Groundwater Transfer Review Summary Form

Application: T-14100

Ground Water Review Form: ☐ Water Right Transfer ☐ Permit Amendment **⊠** GR Modification ☐ Other Applicant Name: Andrews Holdings, LLC \square SW \rightarrow GW \square RA \square OTHER Date of Review: 8/8/2023

Figure 1. Well location Map

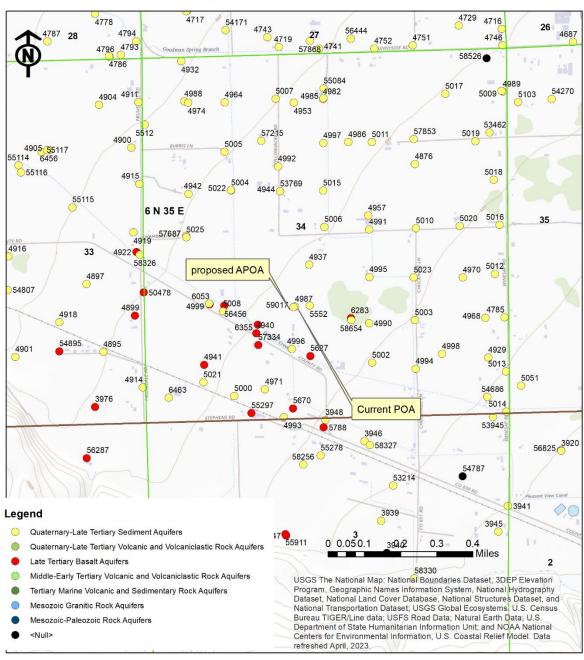
4.	a) Will this proposed change, at its maximum allowed rate of use, likely result in an increase
	in interference with another ground water right?
	☐ Yes ☐ No Comments: <u>The replacement well is located approximately 10 feet from</u>
	the authorized POA. No change in well-to-well interference is expected due to the proximity
	to the original POA.
